Our Ref: 3622\_DPE\_Preshaw\_20171018a\_Ltr\_DRAFT

**Re: DRAFT Response to issues raised by EPA in letter dated 13 September 2017**

Invincible Southern Extension Project (G1817B)

FIGURE 1  
Measurement of Water in  
Underground Working

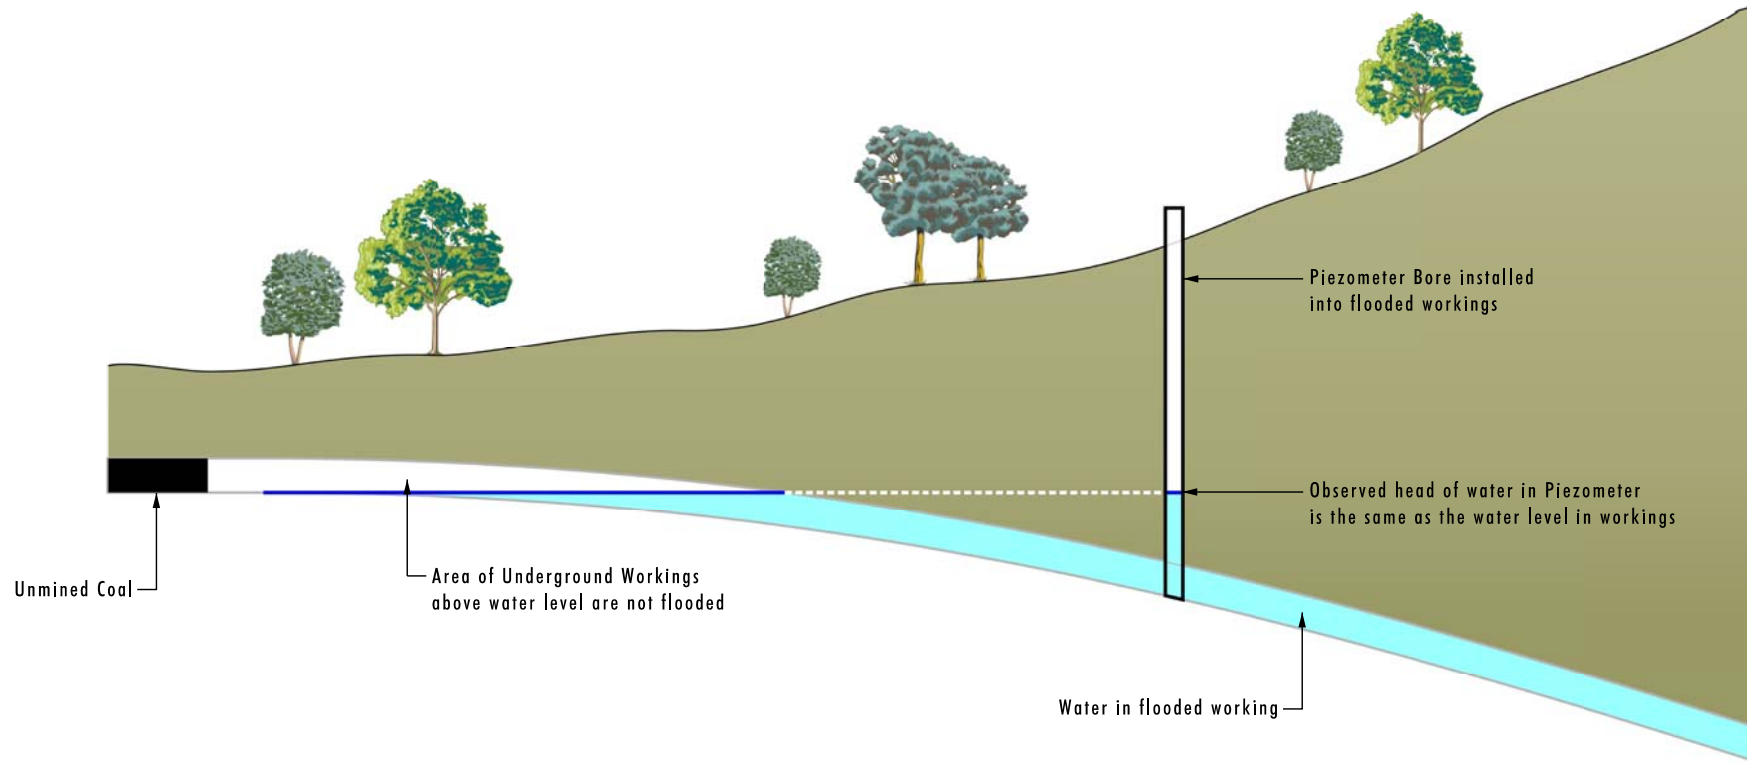
The purpose of BHTH-12 was to measure the head of water in the Ivanhoe No. 2 workings and, through this measurement, calculate the likely volume of water to be dewatered to enable mining of the Southern Extension Area. BH2 was installed to assess whether there was movement of water from Ivanhoe No 2 towards Invincible underground workings. A single bore in the Invincible underground workings in the area selected is considered to provide a highly accurate direct measure of water levels in the entire workings due to their connectedness through the old workings. **Figure 1** provides a stylised cross section of a bore into flooded workings demonstrating how workings are flooded and why a single bore can be an accurate source of data for water levels in interconnected workings.

The measured water levels used to calculate water levels in the Response to Submissions Part B were based on two monthly recorded measurements. The observed maximum level used for these calculations was 900.8m AHD and a conservative estimate of 901m AHD was used for volume calculations. Using the Lithgow seam floor data used for the previous Coalpac assessments and the measured water level data, it was calculated that there was approximately 367 ML of water in the underground workings. This was well below the calculated 1,585 ML of available storage in the Invincible underground workings and, based on these calculations, there was no requirement to discharge water removed from the Ivanhoe No. 2 workings to surface water system downstream from Invincible. Accordingly, as outlined in the Response to Submissions Part B report the initially proposed discharge of water from the former Ivanhoe No 2 workings prior to mining within the Southern Extension Area was removed from the Project as this water would be stored within the former Invincible underground workings.

**Chart 1 – Standing Water Levels observed in BH1 and BHTH-12**

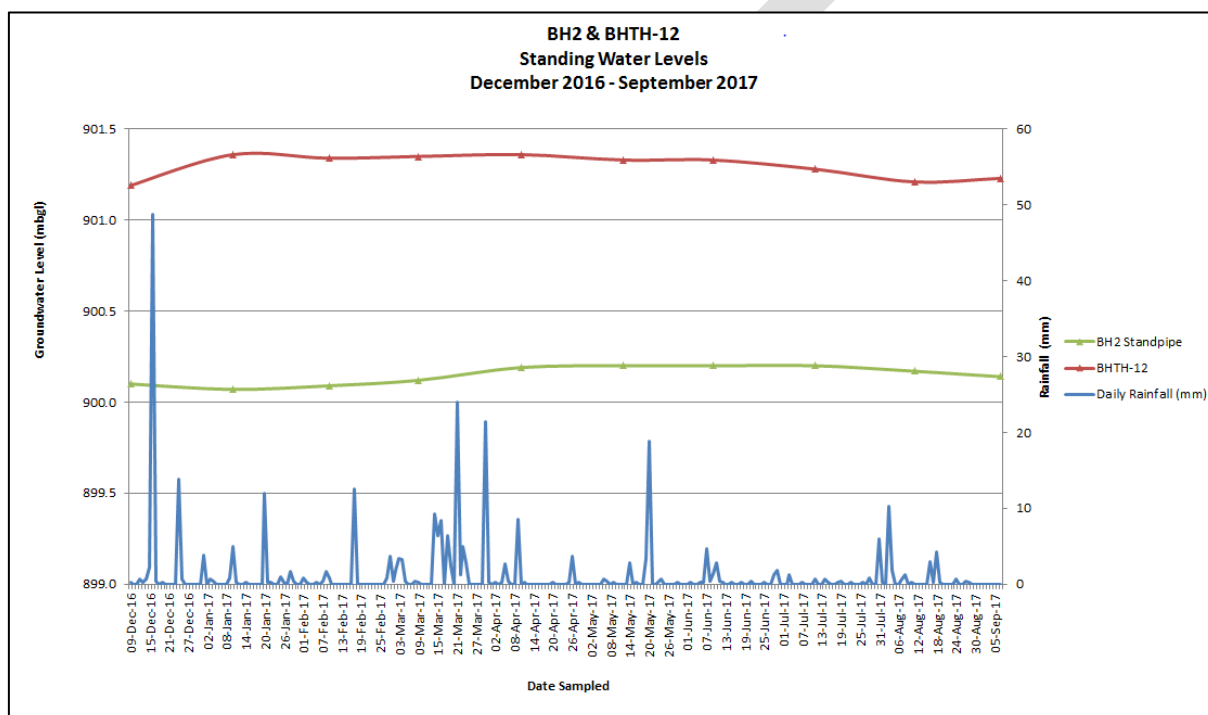
As shown on **Chart 1**, the monitoring data has indicated that water levels in the Ivanhoe workings had remained relatively static over the 10 month monitoring period to within the range 901.19m AHD to 901.36m AHD.

A check against rainfall data (refer to **Chart 1**) indicated no correlation between the minor observed fluctuations and water levels. This indicates that any inflows to the system are effectively balanced by seepage from the system towards the Invincible and Wallerawang workings.

These longer term measurements provide a high degree of confidence in the level of water in the Ivanhoe No. 2 Workings. As shown in **Chart 1**, the maximum observed level over the 10 month monitoring period was 901.36m AHD. The most recent reading (7 September 2017) was 901.23m AHD. For the purpose of conservatively estimating storage volumes in the Ivanhoe No 2 workings, a water level of 901.5m AHD has been assumed. This is 0.5m above the inferred water level height in the calculations outlined in the Response to Submissions Part B assessment and 0.14m above the highest water level observed in the Ivanhoe No. 2 workings.

**FIGURE 3**  
**Ivanhoe No.2**  
**Dewatering Areas**

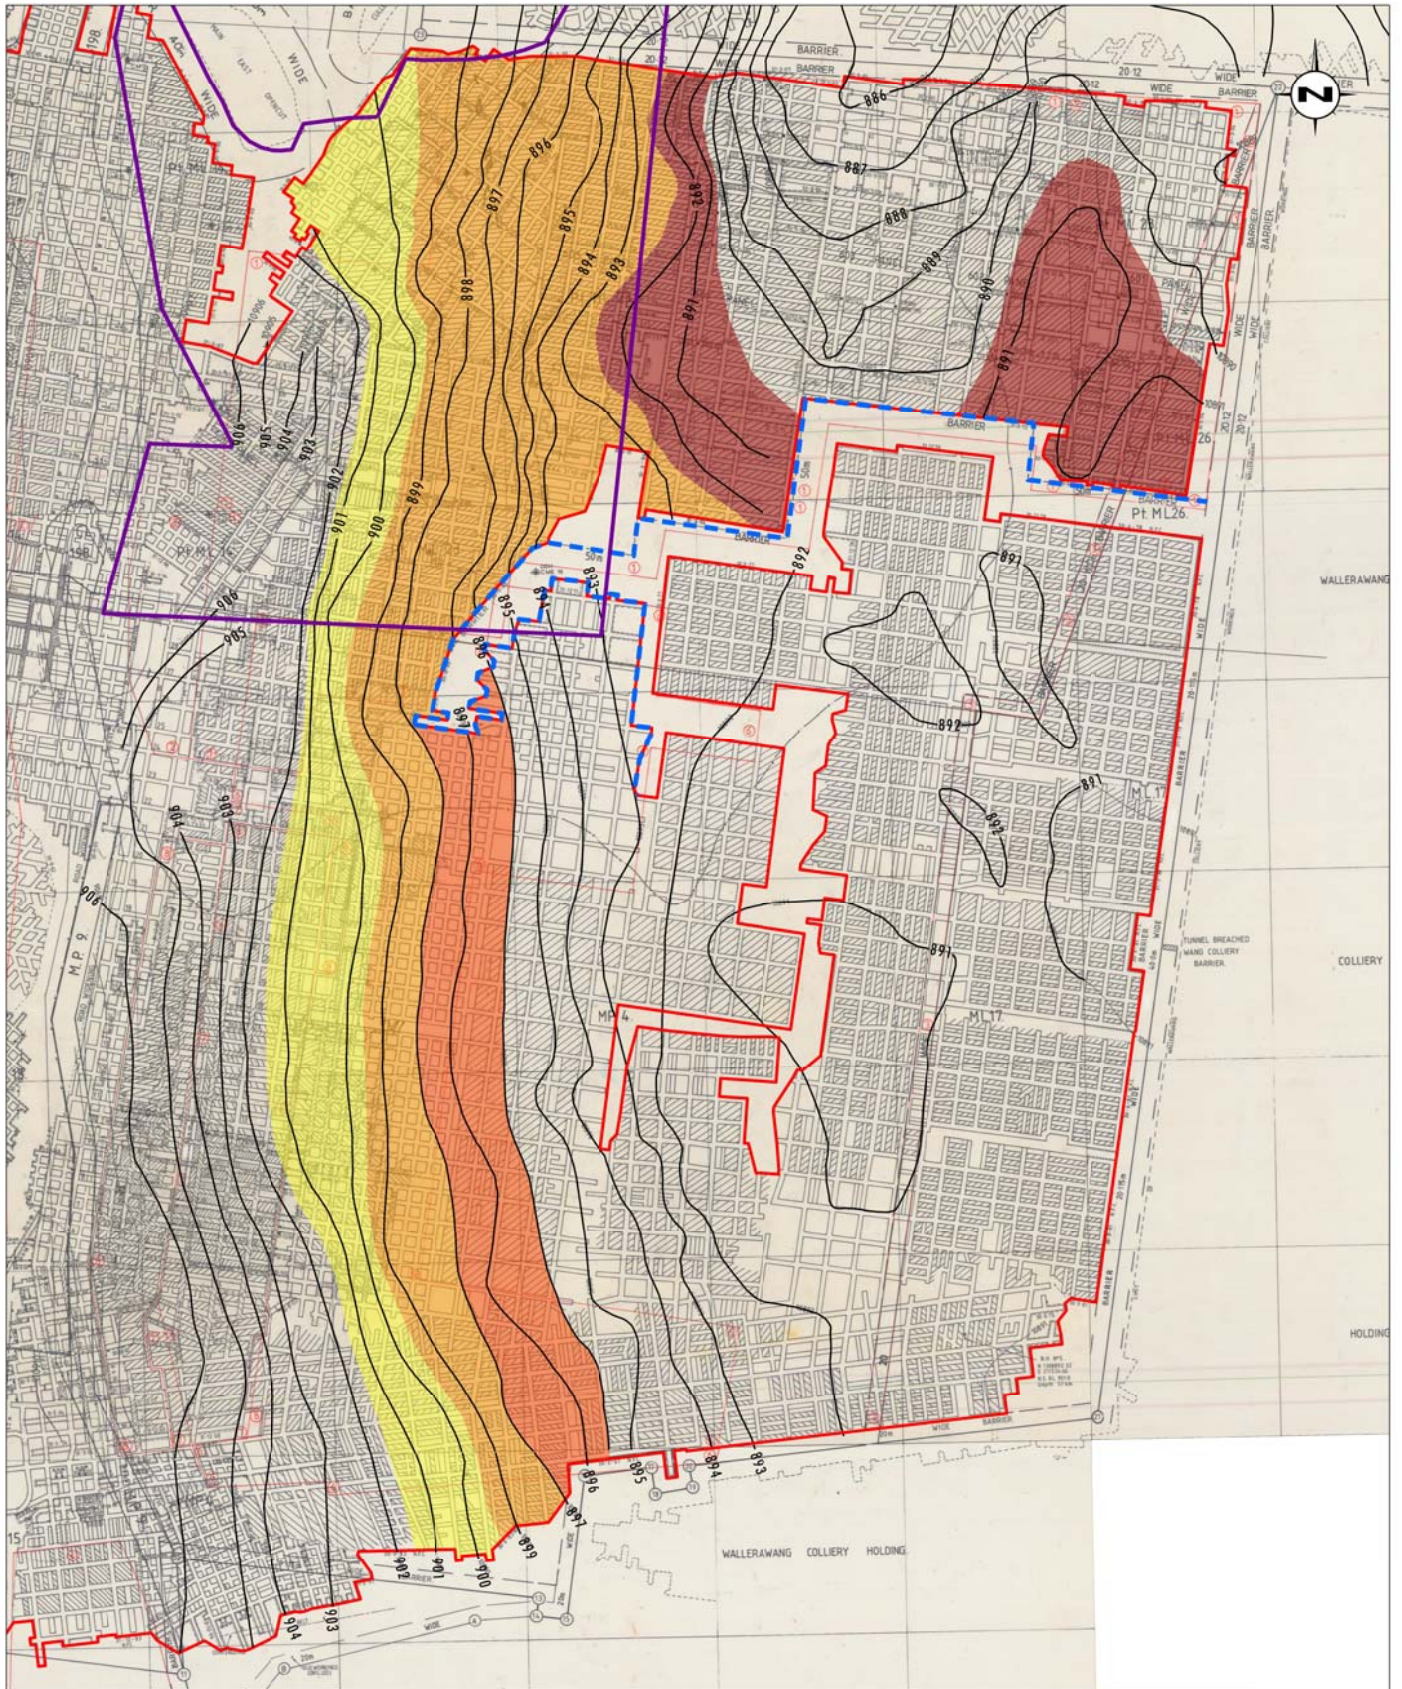
Given the accuracy of the Record Tracings, updated estimates of the extent of water in the Ivanhoe No. 2 workings have been completed. This process has identified that the area of workings flooded is larger than previously understood with the extent of flooding extending to the southern extent of the workings and not just the north eastern corner as had previously been understood. The extent of inferred flooding is shown in **Figure 3**.

On the basis of the additional data obtained through the Record Tracings, a remnant barrier of coal in the south-eastern corner of the Southern Extension Area operates as a dam for water stored below RL 898m AHD, south of this barrier (refer to **Figure 3**). Based on this information, this barrier will be retained and not be mined as part of the Southern Extension Project, subject to further detailed mine planning and approval process with the Resources Regulator (refer to **Section 2.8**). The retention of the barrier to the south east will reduce the volume of water to be removed and ensure that the outcomes of the assessment are met (i.e. water from Ivanhoe No 2 workings is captured and stored within the former Invincible underground workings). It is noted that this will result in some Lithgow and Lidsdale seam coal in this area being sterilised.

- Workings are flooded to RL 901.5m AHD (refer to **Figure 3**). That is, the ‘beach’ level in the underground workings will occur at a seam floor depth of 901.5m AHD (maximum observed water levels in the past 10 months of monitoring was 901.36m AHD).

- The existing coal barrier in the Ivanhoe No 2) workings (as shown in **Figure 3**) will initially be retained, meaning water below 898m AHD to the south of the barrier will not need to be dewatered (refer to discussion in **Section 2.5**). For the purposes of calculations, water above a head of 898m AHD in the areas south of the Barrier (i.e. areas with a seam floor level of between 896AHD and 898m AHD) will be removed as part of the dewatering process. Following dewatering, approximately 50% of the water currently in the void space in the areas where seam floor levels south of the Barrier are between 896m AHD and 898m AHD (refer to **Figures 3 and 4**) will be removed.

As noted above, the review of the RTs has identified an internal barrier in the Ivanhoe No. 2 workings (refer to **Figure 3**). As also noted above, this process of further detailed mine planning and removal of old workings would be subject to the approval processes of the Resources Regulator (refer to **Section 2.8**). The original mine plan for the Southern Extension Project would have resulted in the partial removal of this barrier however, if retained, the barrier would limit the amount of water needing to be removed from the Ivanhoe No 2 workings. It is proposed to retain a 50m barrier in this area in both the Lithgow and Lidsdale Seams (refer to **Figure 3**). The effect of the retention of the barrier is that water in the Ivanhoe No.2 workings will have a static head at RL 898m AHD to the south of the barrier; and as such water stored below RL 898mAHD to the south of the barrier will be retained in the workings.

FIGURE 4  
Calculation of Water to be Removed

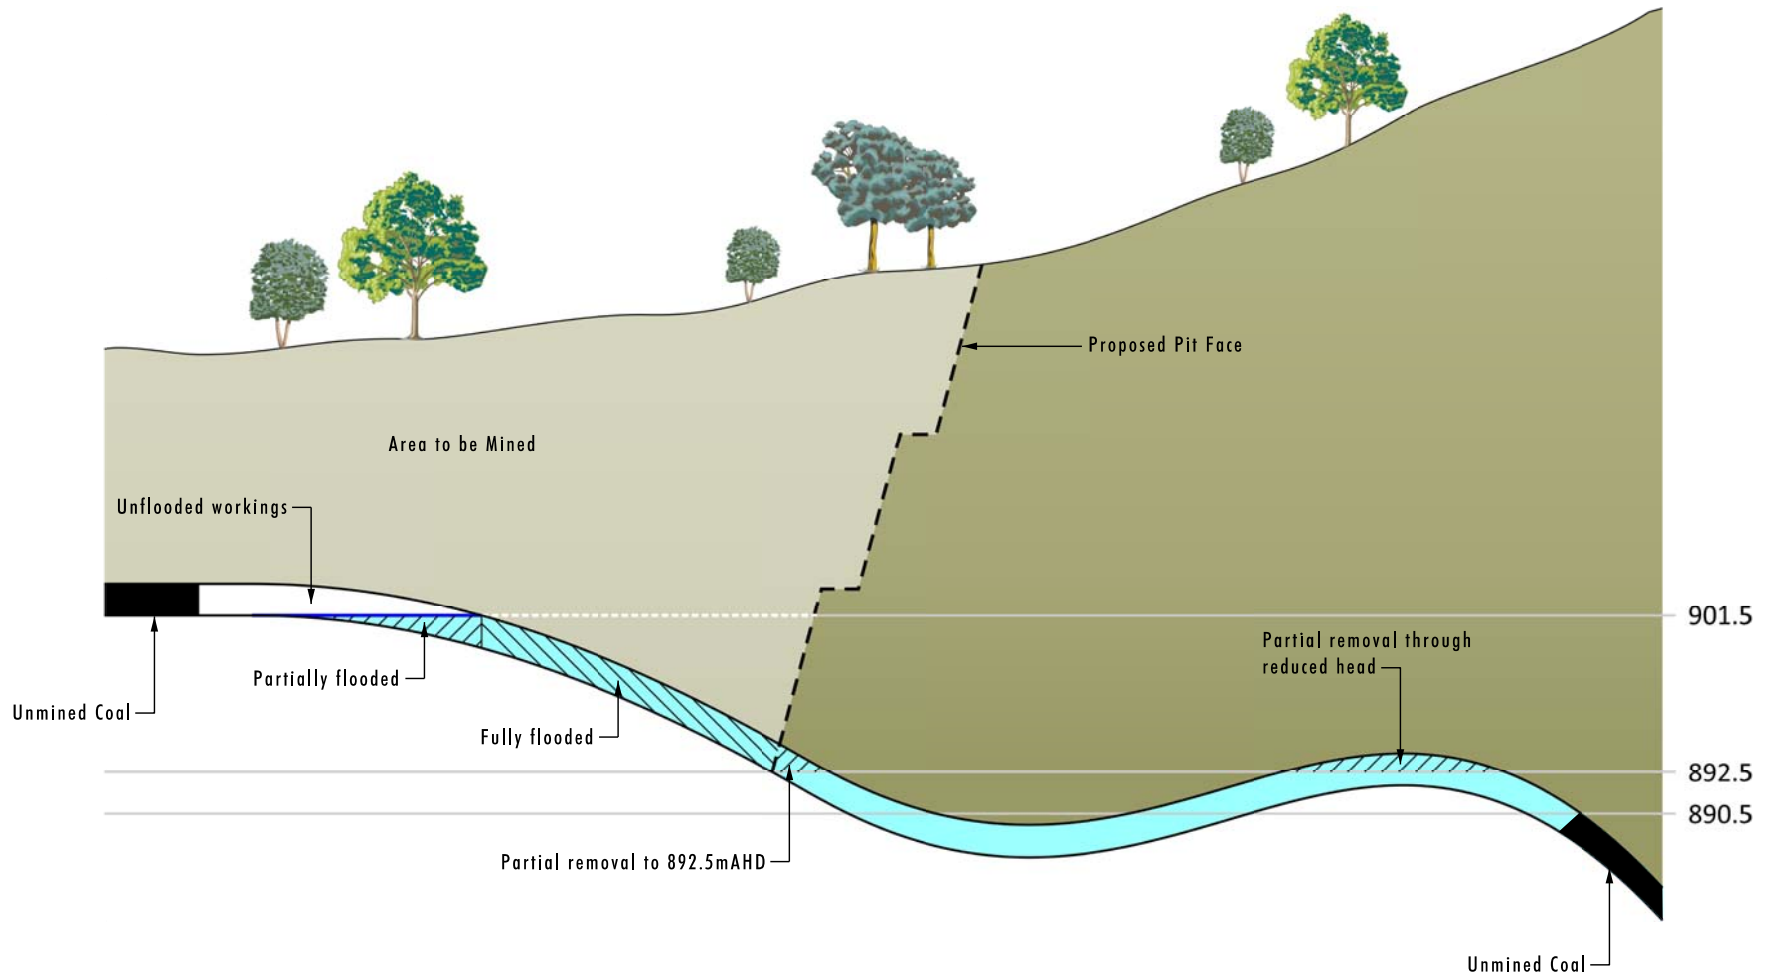
- There has been 64% recovery of coal in the mined areas of Ivanhoe No. 2 workings.
  - All workings in area of flooding below 899.5 and above 892.5 m are assumed to be flooded floor to ceiling. 50% of the total void space in the areas where seam floor levels are between 899.5 and 901.5m AHD are partly flooded and the voids in these areas are assumed to hold 50% of the volume that is held in the fully flooded sections. Following dewatering, up to 50% of the total void space in the areas where seam floor levels are between 890.5 and 892.5 (refer to **Figures 3 and 4**) will contain water which will also be removed.

Area	Area (ha)	Area (m <sup>2</sup> )	Assumed void space	Void Space requiring dewatering	Assumed working height (m)	Volume to be removed (ML)
Area A	19.2664	192664	64%	50%	2.00	123.31
Area B	31.7526	317526	64%	100%	2.00	406.43
Area C	11.089	110890	64%	50%	2.00	70.97
Area D	15.6537	156537	64%	50%	2.00	100.18
<b>Total</b>						<b>700.9</b>

Based on these conservative assumptions, the volume of water required to be removed from the Ivanhoe No. 2 workings to enable extraction of the proposed Southern Extension Area is 701 ML.

**Potential storage available using 2014 Invincible Colliery water level**

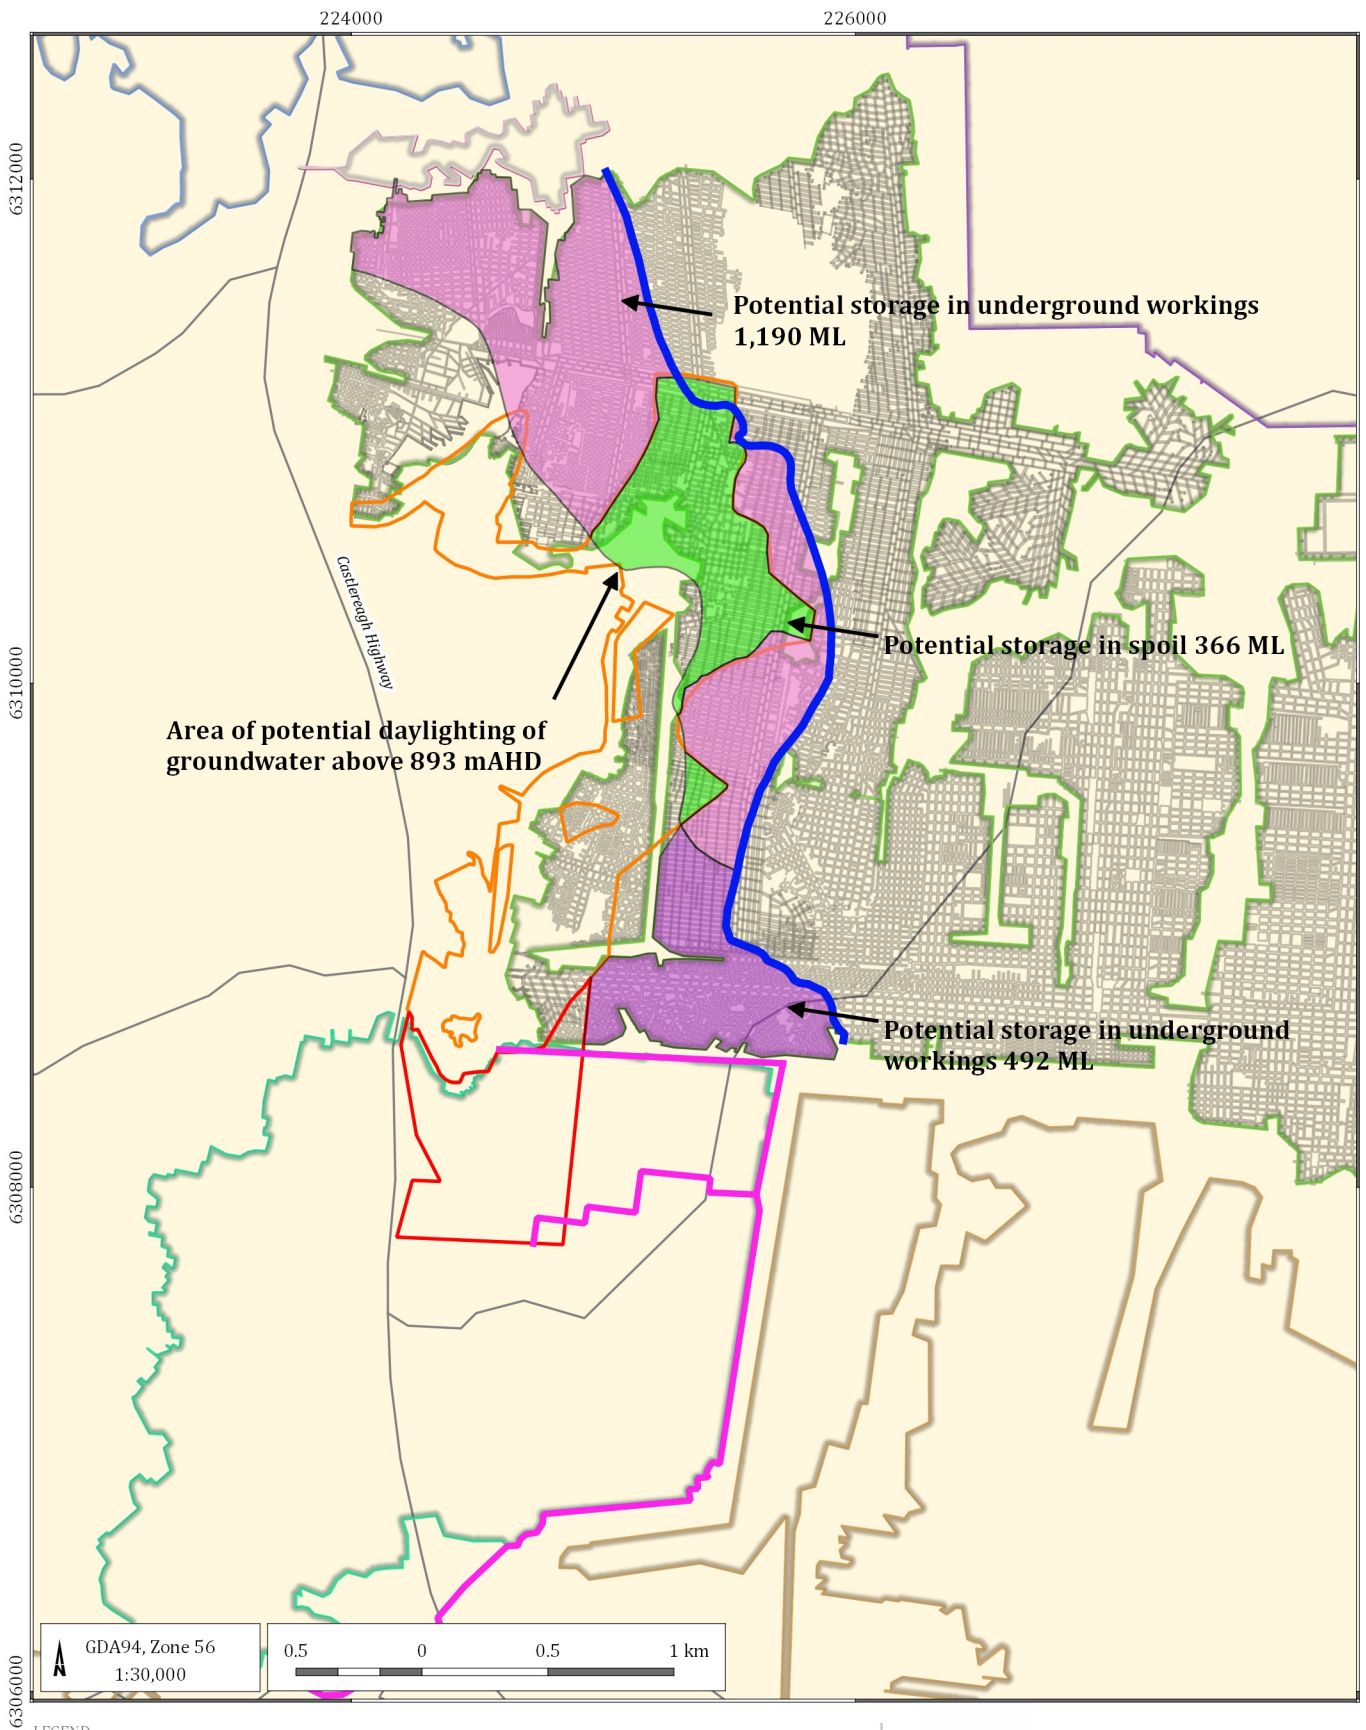
The review of the Record Tracings for the former Invincible underground workings also identified discrepancies in the seam floor data previously used to assess available storage in these workings. The seam floor data in the Invincible Record Tracings also explains the discrepancy between the observed tide mark and the floor seam data discussed in Appendix 5 of the Environmental Assessment.

Based on the surveyed seam floor data in the record tracings, there is a larger volume of available storage in the Invincible underground workings than had previously been calculated. The maximum long term storage level remains as previously assessed at 893m AHD. This level is the point at which water stored in the Invincible underground workings (and spoil within the rehabilitated Invincible open cut workings) would 'daylight' as a spring in the catchment of Cullen Creek.

Revised conservative calculations of available storage in Invincible indicate that there is approximately 2048 ML of storage available (refer to **Figure 5**). These storage volumes assume overburden is emplaced in all void areas meaning the operational storage levels are conservative as the Northern Void will remain open until the completion of mining.
